TECHNICAL BULLETIN

REWORK OF STATIC PRESSURE TUBE INSTALLATION TO MINIMIZE ALTIMETER NEEDLE OSCILLATION

All 500 Models 369H Series Helicopters

Figure 1. Rework of Static Pressure Tube Installation

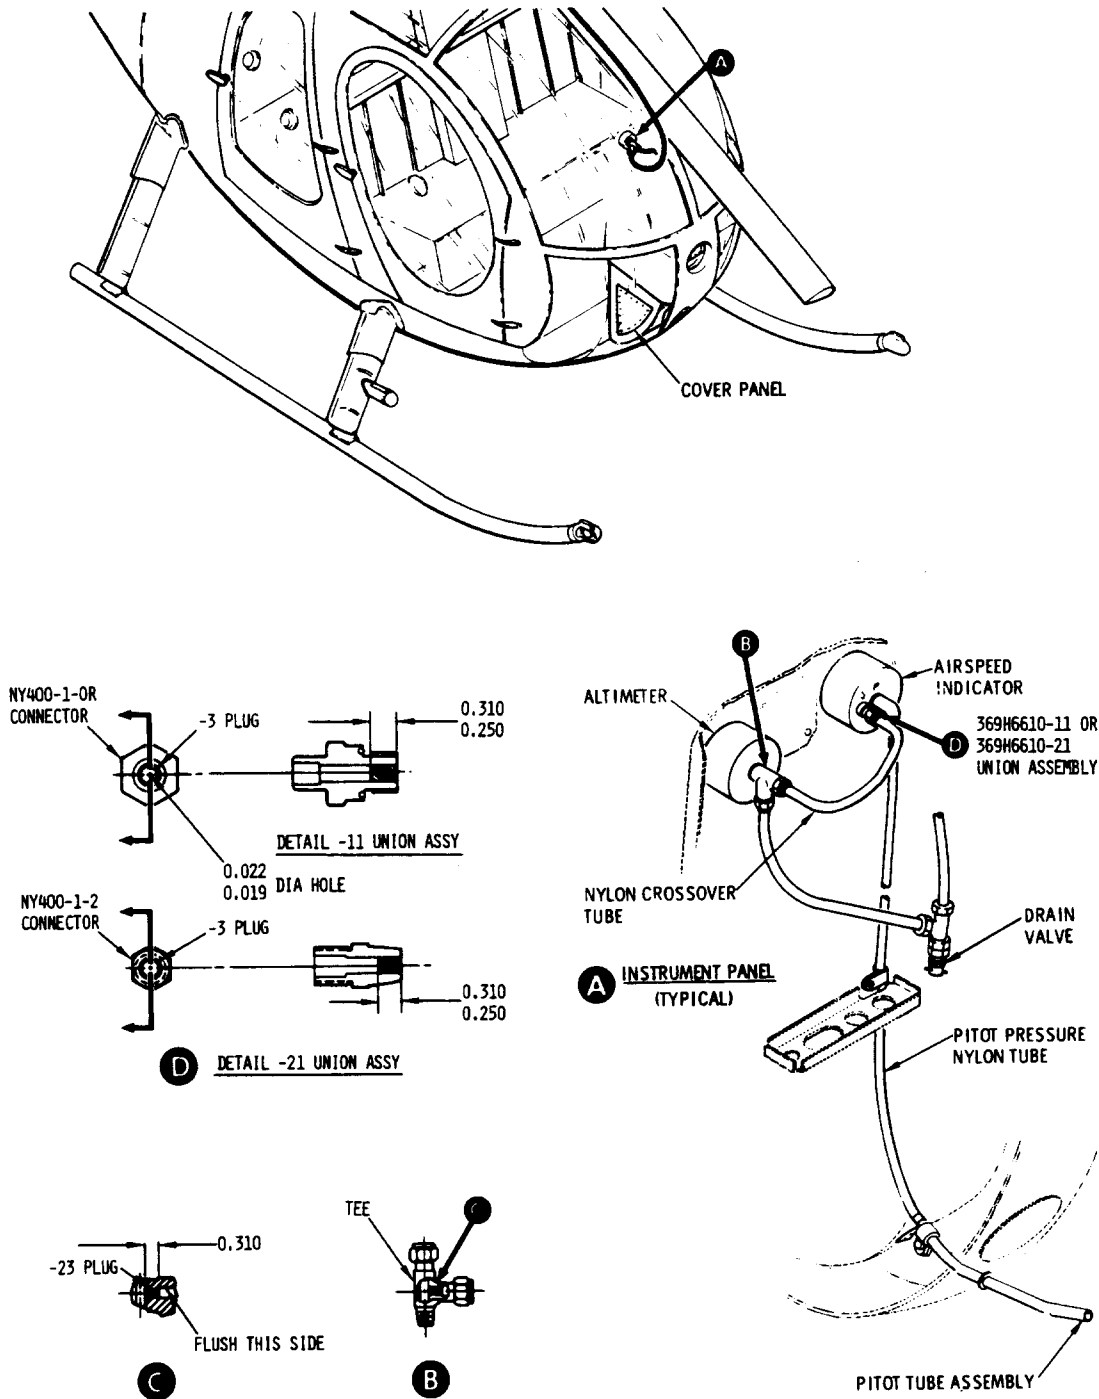
The information given in this Service Information Notice lists a procedure for rework of the hardware connecting the crossover tube between the altimeter and airspeed indicators on the instrument panel to reduce needle bounce. The rework consists primarily of removing the existing 369H6610-3 plug from the connector at the airspeed indicator and installing a new 369H6610-23 plug in the existing tee at the altimeter indicator.

- a. Check that all electrical power is OFF.
- b. Remove instrument panel fairing and hood, per Basic HMI.
- c. Disconnect drain tube from 369H6628 tee at altimeter indicator. (See Figure 1.)
- d. Press fit new 369H6610-23 plug into tee as shown, reconnect drain tube to tee. (See View B.)
- e. Disconnect crossover tube from connector at airspeed indicator.
- f. Remove existing -3 plug from 369R6610-11 or -21 union assembly.
- g. Reconnect crossover tube to connector at airspeed indicator.
- h. Reinstall instrument panel fairing and hood.
- i. Perform flight test to check instrument operation.
